**CABINET MEMBER FOR HIGHWAY MANAGEMENT –
16 DECEMBER 2021**

**HARWELL – GROVE ROAD: PROPOSED TRAFFIC CALMING
BUILD OUTS**

Report by Corporate Director, Environment and Place

Title: Grove Road Traffic Calming Engineering Layout - Sheet 1 of 2

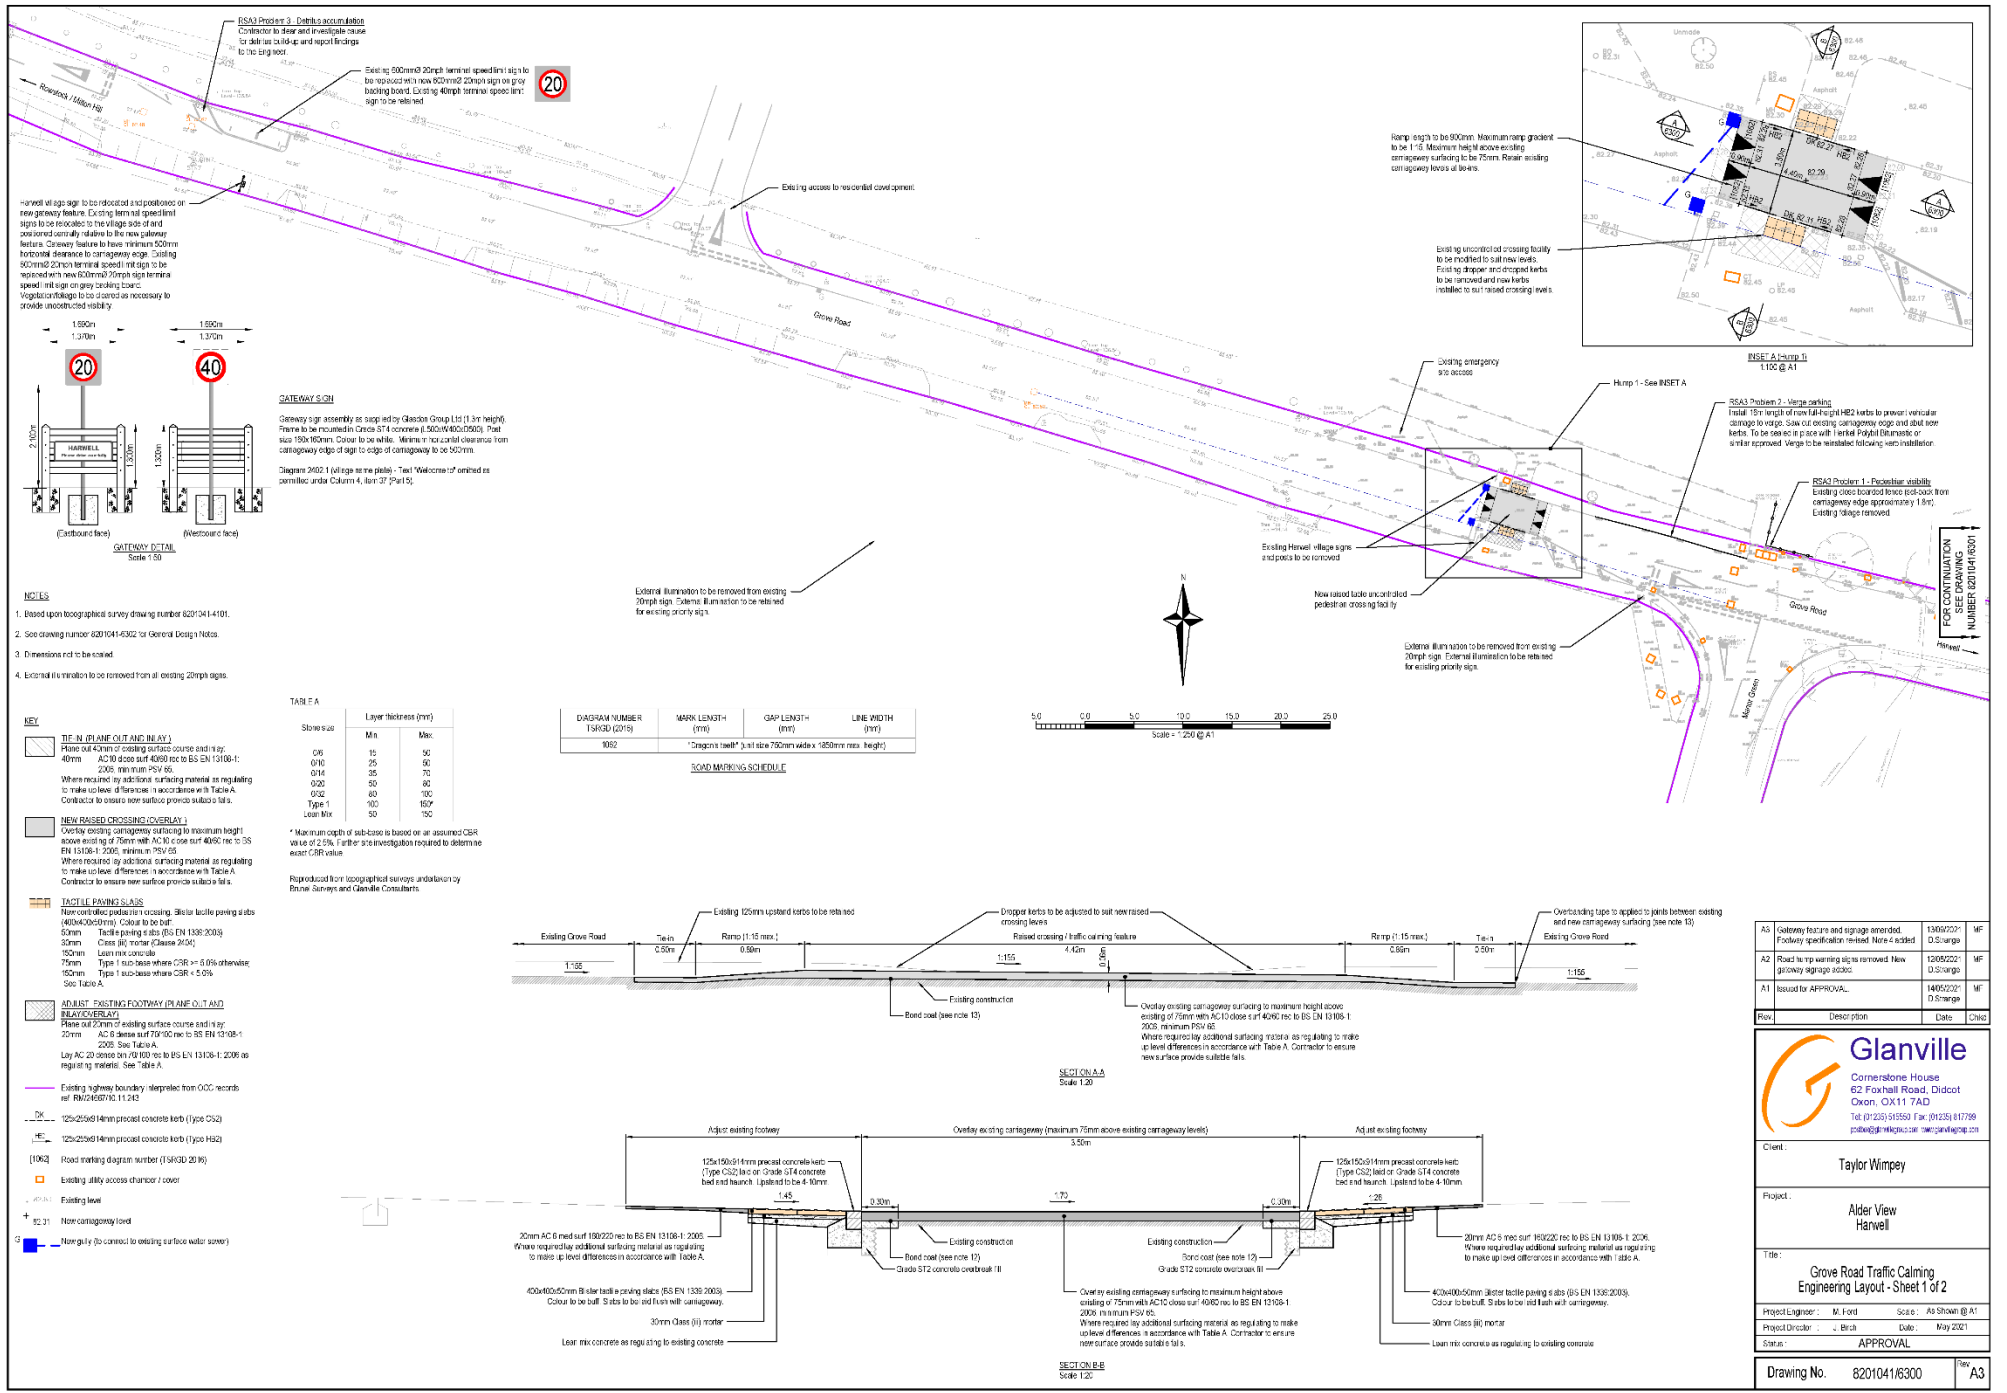
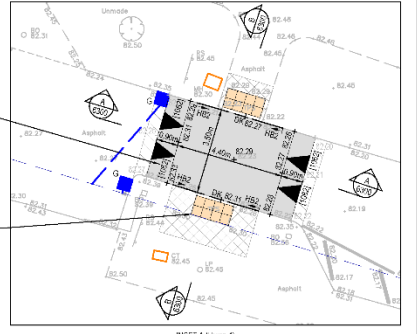
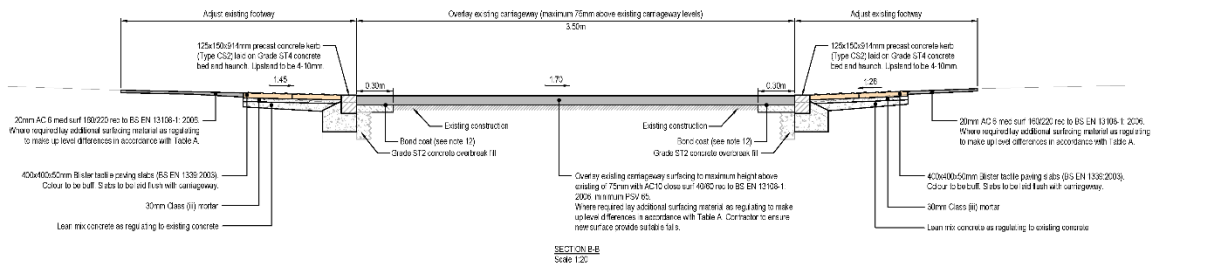
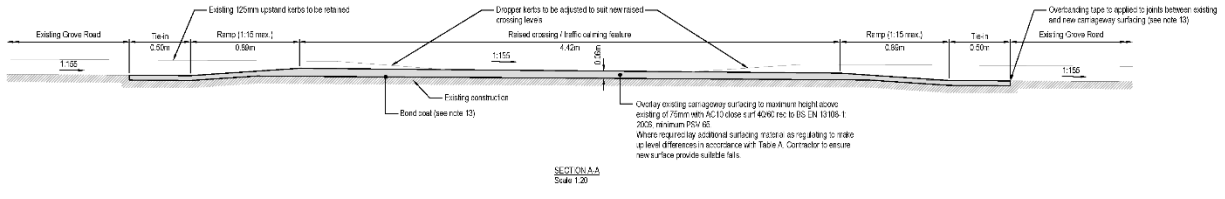
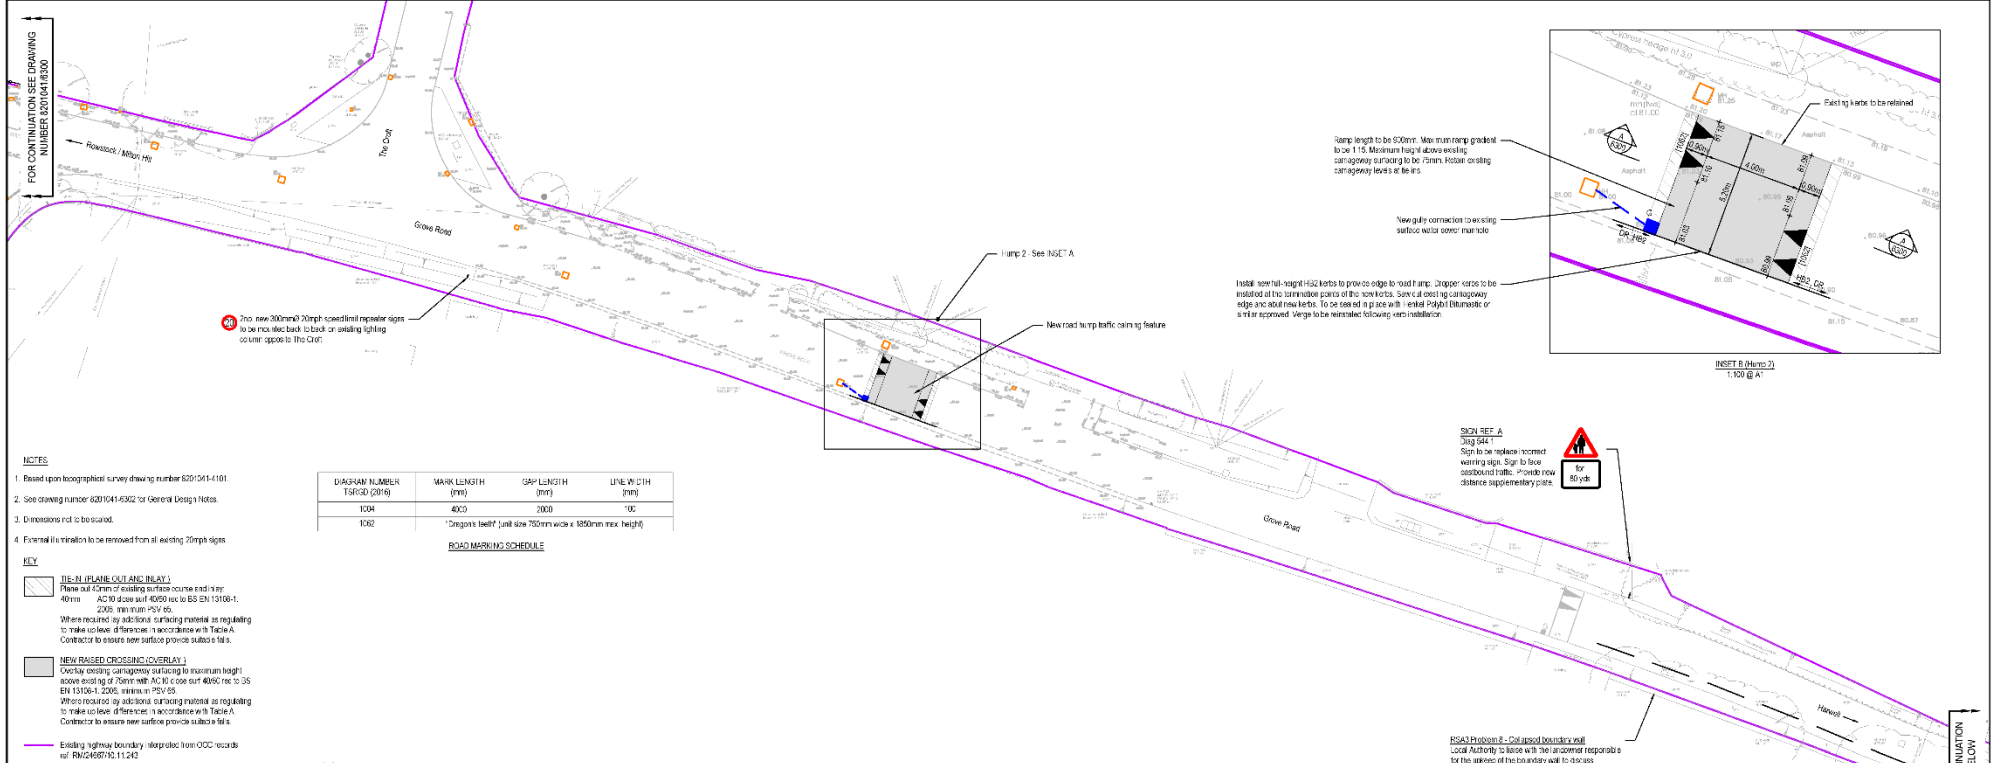
(3) Vale of White Horse District Council (Planning)	No objection
(4) Local Resident, (Harwell, Grove Road)	Object - The road needs to be made more suitable for all users. It needs to be widened for cars and resurfaced. Then it can be considered for pedestrians, a walk or cycle lane should be created. Adding two speed bumps is a waste of funds. It will just add to the existing poor road surface.

(5) Local Resident, (Harwell, White Hart Way)	Object - There are already 2 traffic calming structures in place
(6) Resident, (Didcot, Maple Road)	Object - There are enough obstacles already on this road to require further traffic calming measures

(7) Resident, (Oxford, Rymers Lane)	Object - A raised 'traffic calming' measure is not necessary here - instead a speed activated warning sign should be deployed. This is greener, more environmentally sound (due to the increased pollution from a car braking and accelerating unnecessarily) and less obstructive to the flow of traffic.

<p>(8) Local Resident, (Harwell, Hill Mead)</p>	<p>Concerns - Traffic doesn't seem to adjust speed before reaching existing traffic calming measures on Grove Rd heading towards village. Would it not be sensible to place speed hump at the 40-20 transition point? Too many cars approach the narrow at 40 and can't see oncoming vehicles due to brow.</p>
<p>(9) Local Resident, (Harwell, White Hart Way)</p>	<p>Concerns - I support traffic calming measures on all sections of grove road including this section. I however have concerns that traffic speeds from hump 1 Westbound to RSA Problem 3 (the island heading towards Rowstock/Milton Hill) will continue to far exceed 20mph. Although only a 100m distance past the Fidlers Orchard junction, I would encourage the reviewer to consider a further speed deterrent, such as another speed hump, closer towards the Fidlers Orchard Junction.</p> <p>Furthermore, when travelling eastbound from Milton Hill towards Harwell, on Grove road, the current 'island' located near the Fidlers orchard junction has no priority for cyclists. Meaning a cyclist has to give way/interrupt their journey to oncoming road traffic, then recommence uphill, around the island. With no education in road traffic, I ask why does this island/lump of tarmac need to protrude continually from the left hand embankment to the centre of the road, could it not leave a say 1m gap for cyclists to squeeze through - filtered permeability?</p> <p>I suspect this may be the incorrect forum to raise more pressing concerns about the other 1,200m of uncontrolled road from the Fidlers orchard junction to the A4130 (Abingdon Road).. unsuitable road surface, no pedestrian access, dangerous, dark, horses travelling, buses crashing. Where do I begin?</p>

<p>(10) Local Resident, (Harwell, Fidler's Orchard)</p>	<p>Concerns - Concerns that there is no traffic calming beyond Alder View (heading towards Rowstock) where the traffic is very fast and the road narrow</p>
<p>(11) Local Resident, (Harwell, Crown fields)</p>	<p>Concerns - Too many cars speeding - rat run</p>
<p>(12) Local Resident, (Harwell, Ham Corner)</p>	<p>Concerns - I think it's definitely a good idea to put traffic calming measures in place as cars do drive too fast down Grove Road.</p> <p>I also think it's really important that there's more signage/road paint on the shared section of road near the High Street - it feels dangerous walking on the footpath part at the moment because it's not clear to drivers.</p> <p>I also think there needs to be a footpath built all the way along the Grove Road from Alder View to the Old Farm Shop</p>

as the road is very narrow/windy and people walk along it all the time which is really dangerous without a path.
(13) Online response, (unknown)	Concerns – How is this going to protect people turning out of Alder View? They come from the 40mph zone and barely slow down. We pull out to enter the 40 zone and they are already on the wrong side of the road speeding. It needs a speed bump as you enter the 20 zone.

(14) Online response, (unknown)	Concerns – Is it proposed that works to alleviate frequent flooding on Grove Road will also be dealt with at the same time as these works?

11. Noting the above, the concerns over the condition and width of the road are outside the scope of the scheme that has planning permission. Furthermore it is not possible to widen the road due to the available highway land without removing the footway all together. The speed humps will further reduce the speed of vehicles and thus make this road safer for pedestrians and control the speed of traffic throughout the entire day. A vehicle active sign would not provide the same level of speed reduction as physical traffic calming and this is the reason humps have been proposed. A noise survey on the proposals has taken place with no significant increase in noise anticipated.
